# DANE COUNTY DEPARTMENT of PUBLIC WORKS, HIGHWAY and TRANSPORTATION

RFB NO. 313086 - ADDENDUM NO. 3

### ARCTIC ANIMAL EXHIBIT AND CONCESSIONS

**SG1.0**

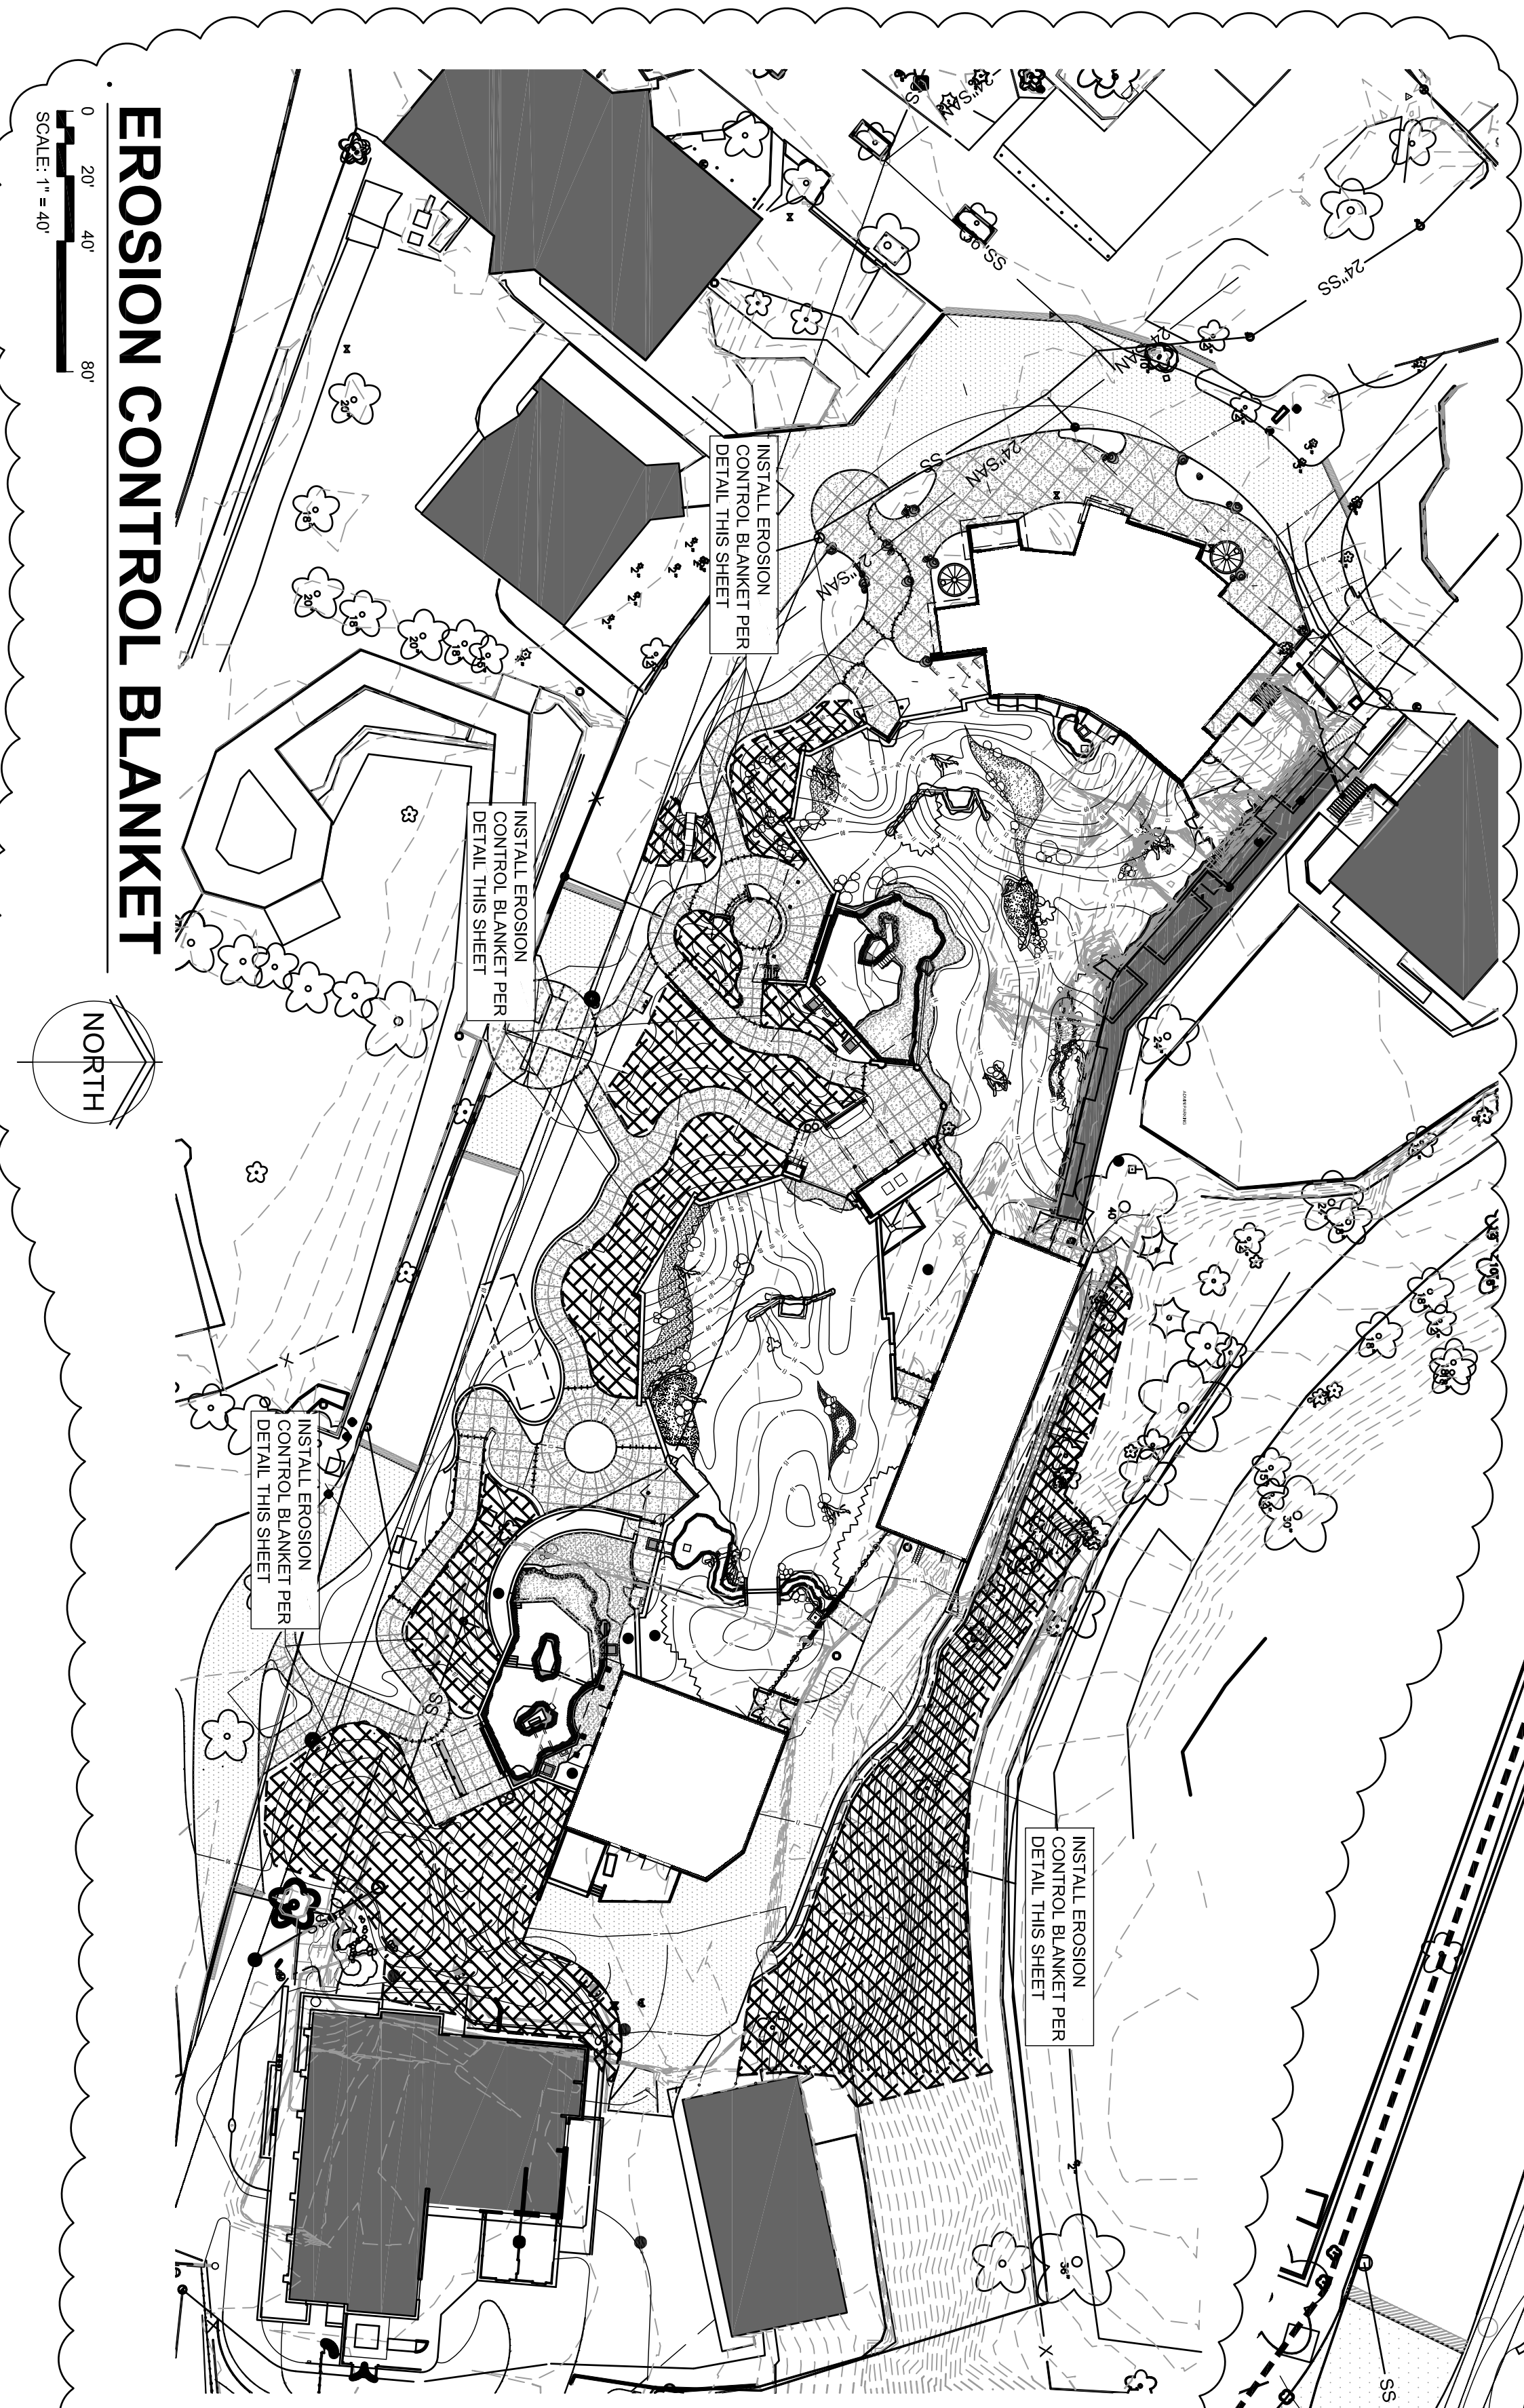
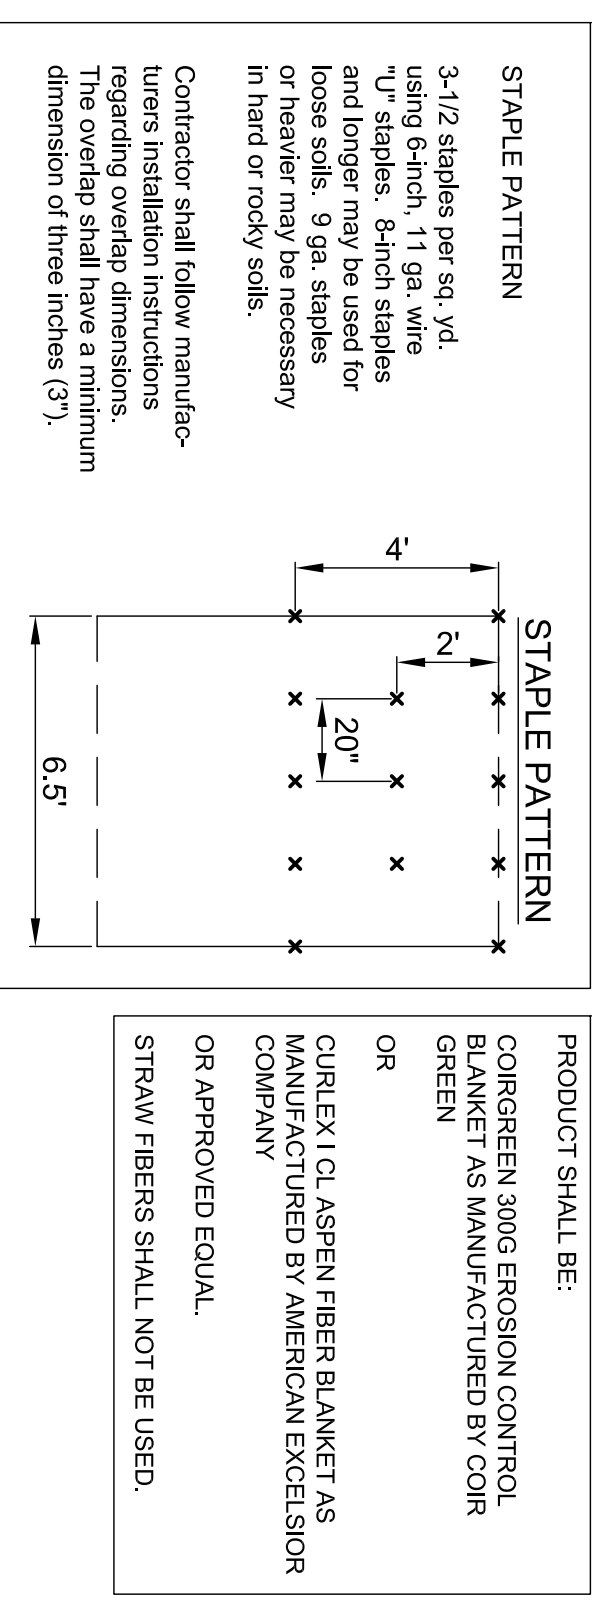
Added erosion control blanket enlargement at bottom of sheet. Delete current sheet SG1.0; replace with new Sheet SG1.0, issued with this addendum.

**SG1.2**

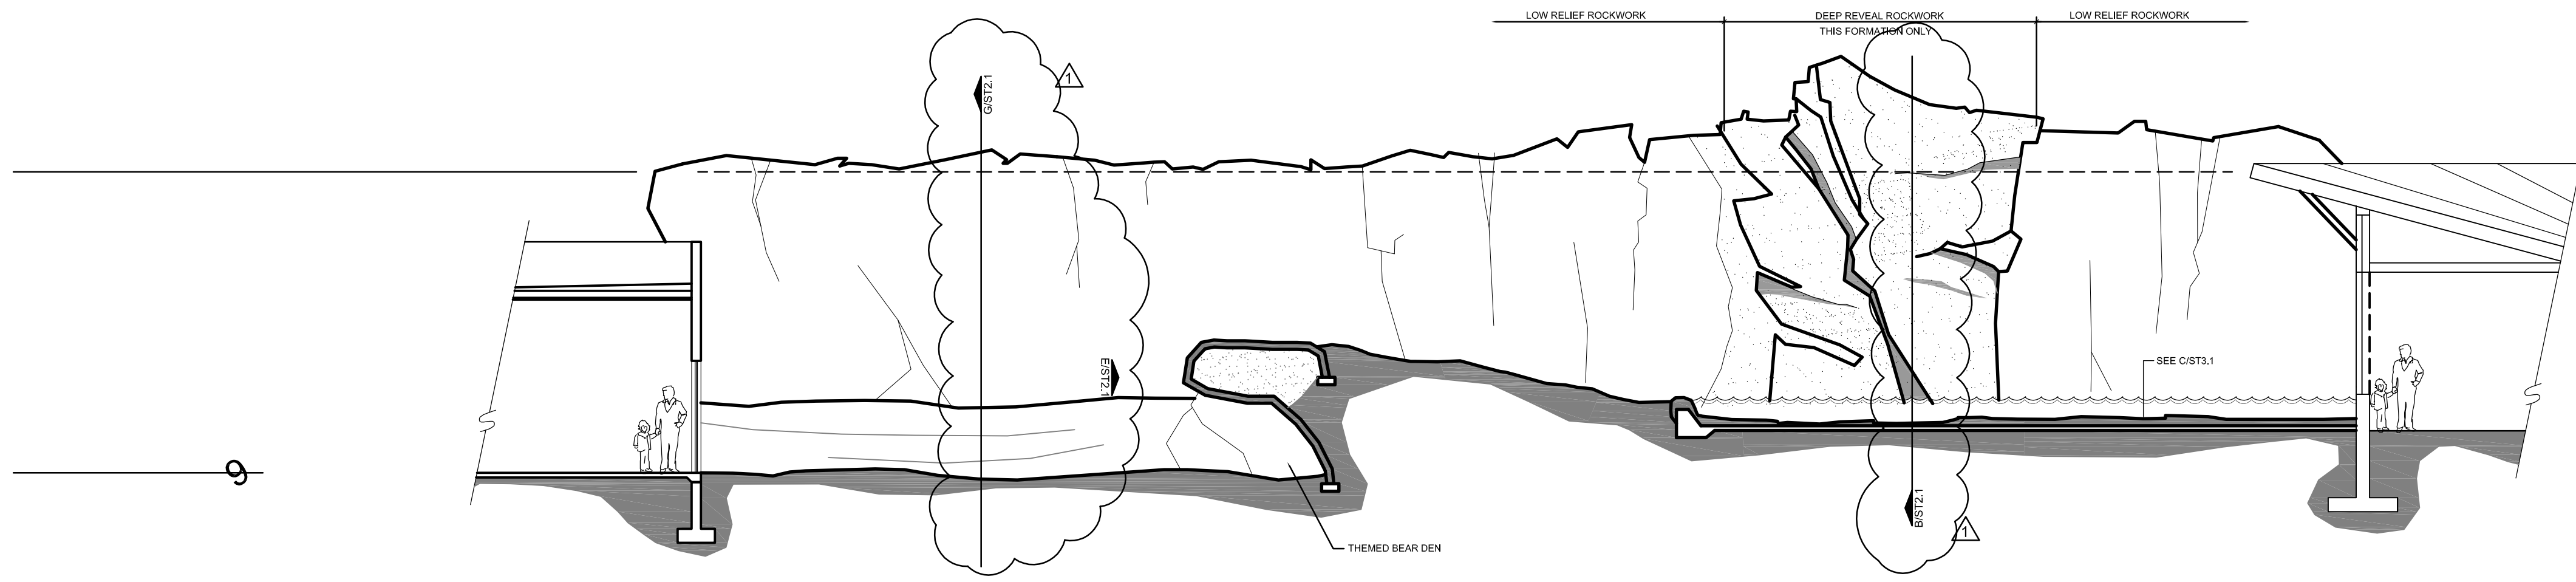
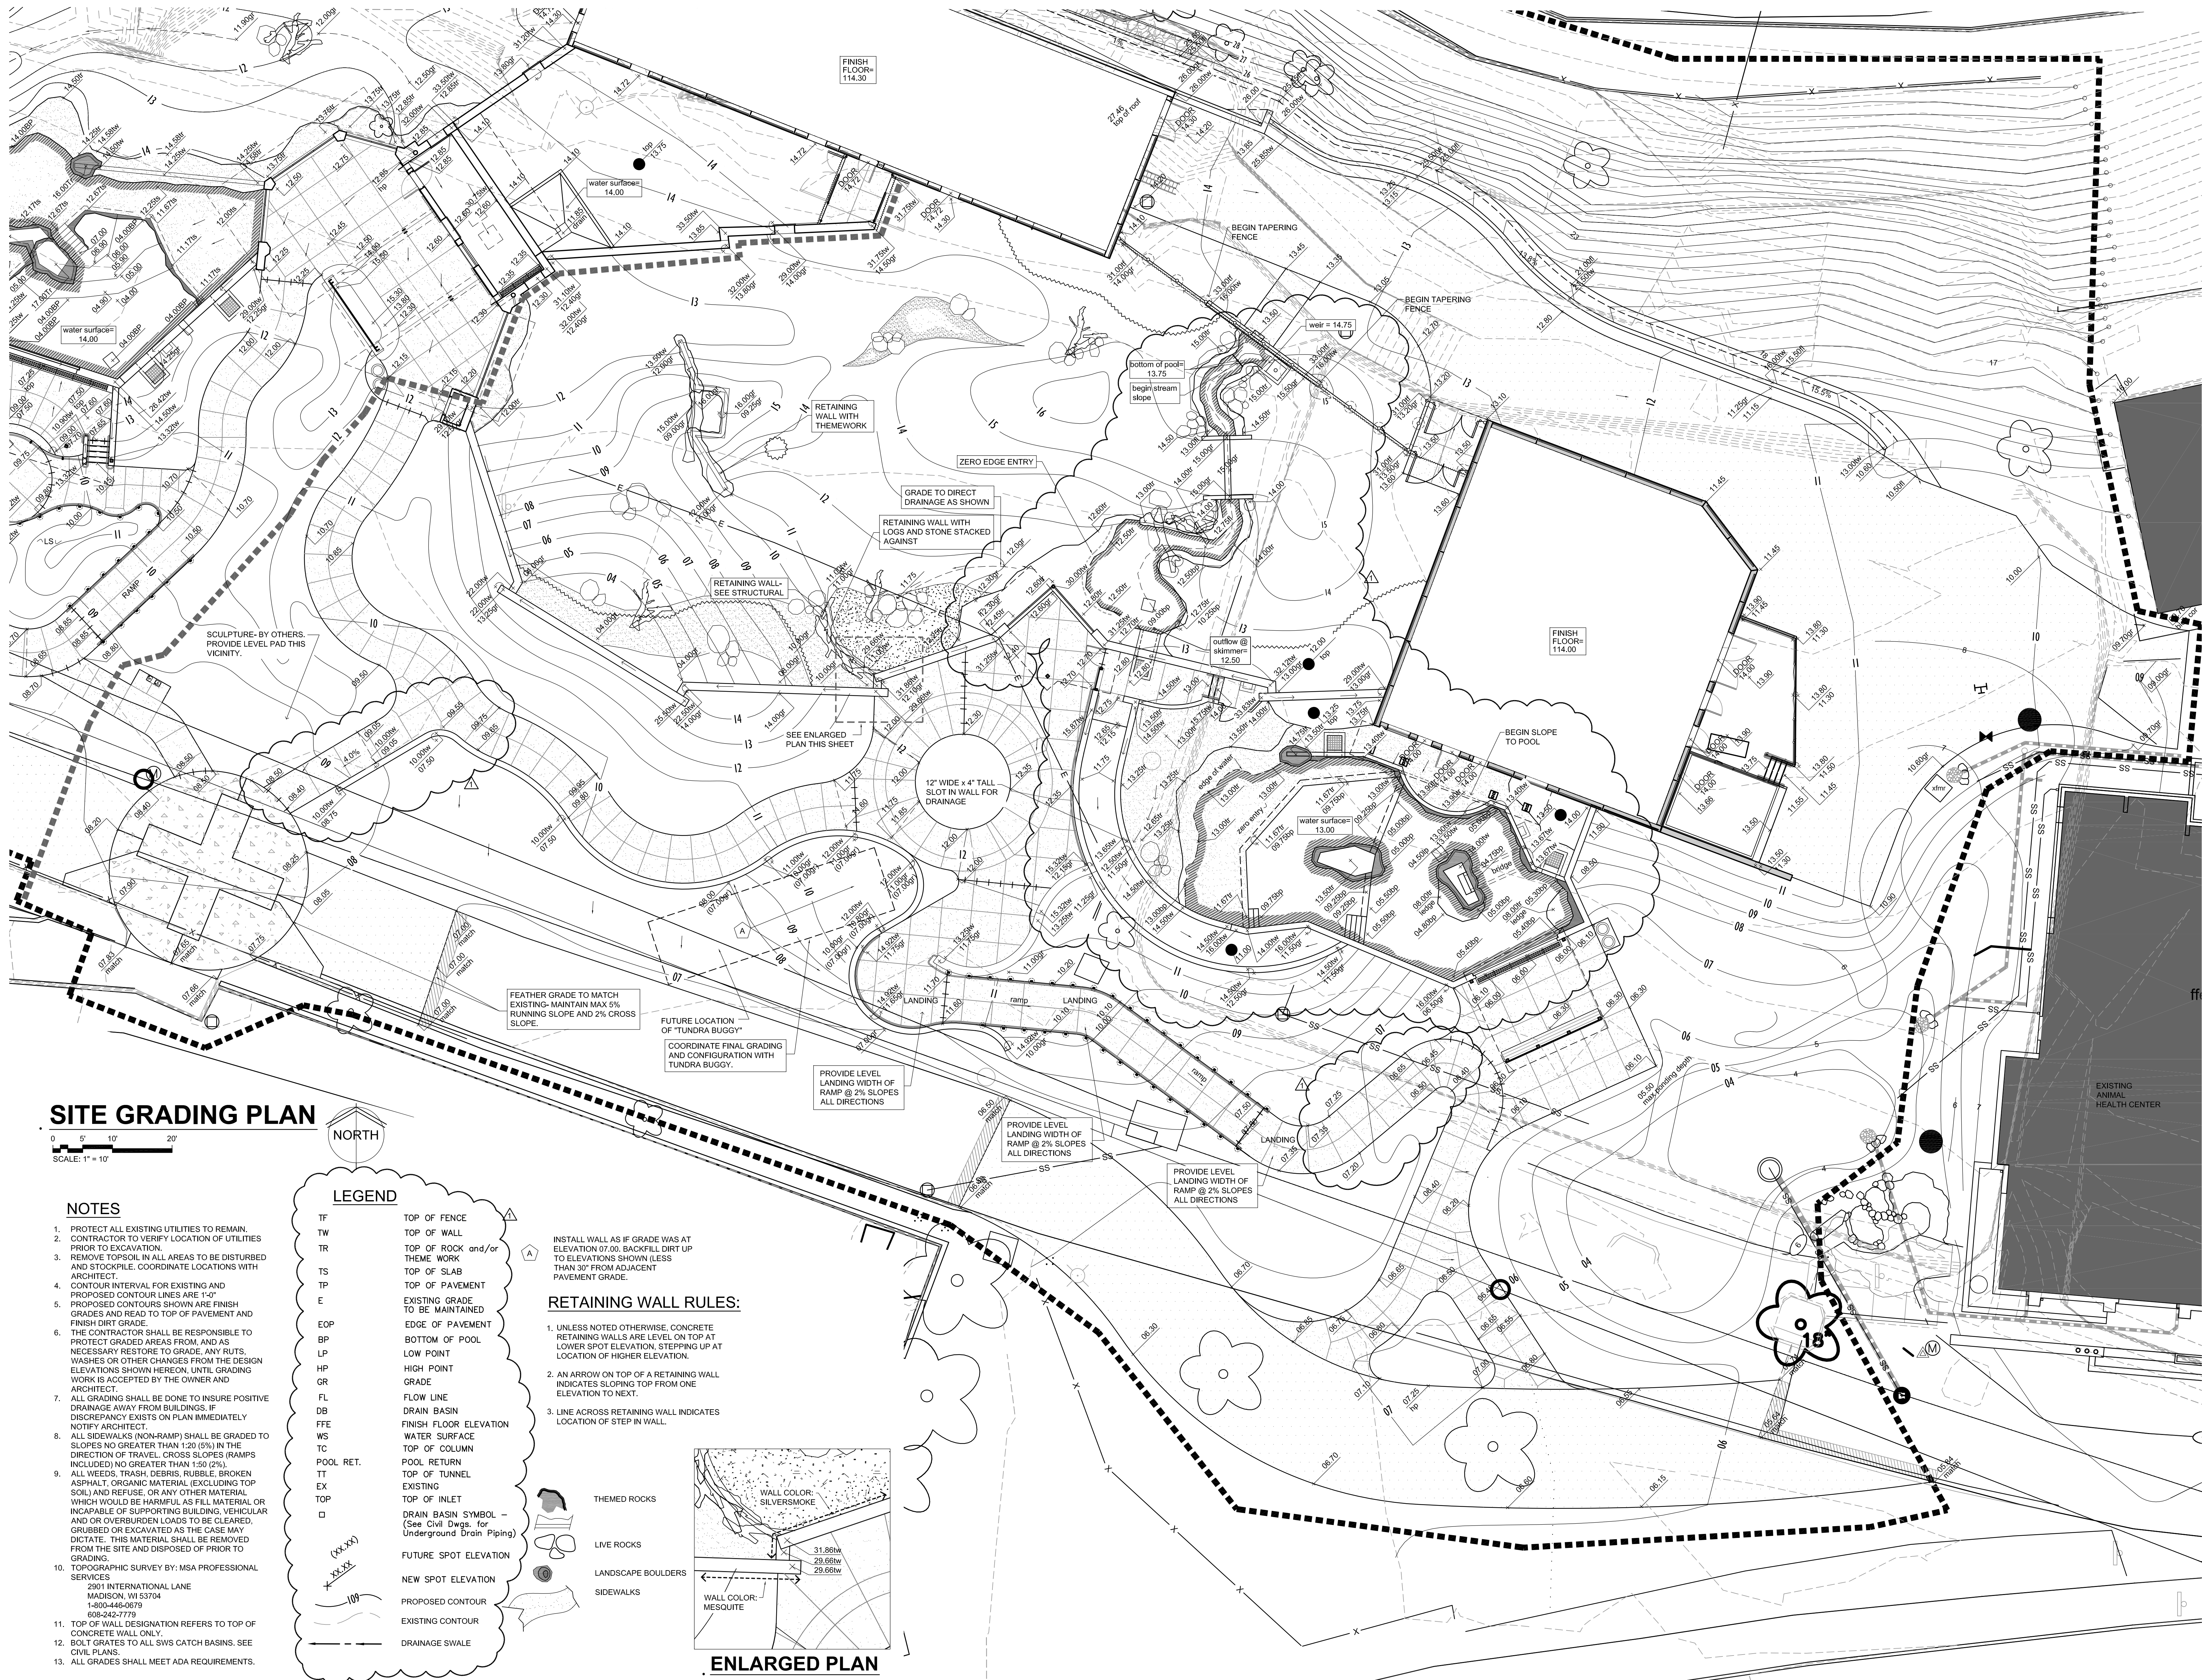
- Minor grade modifications- highlighted on plan. Delete current sheet SG1.2; replace with new Sheet SG1.2, included with this addendum.
- Elevations clarified at pools. 'ts' denotes elevation at top of structural slab. 'tr' denotes top of rockwork elevation.
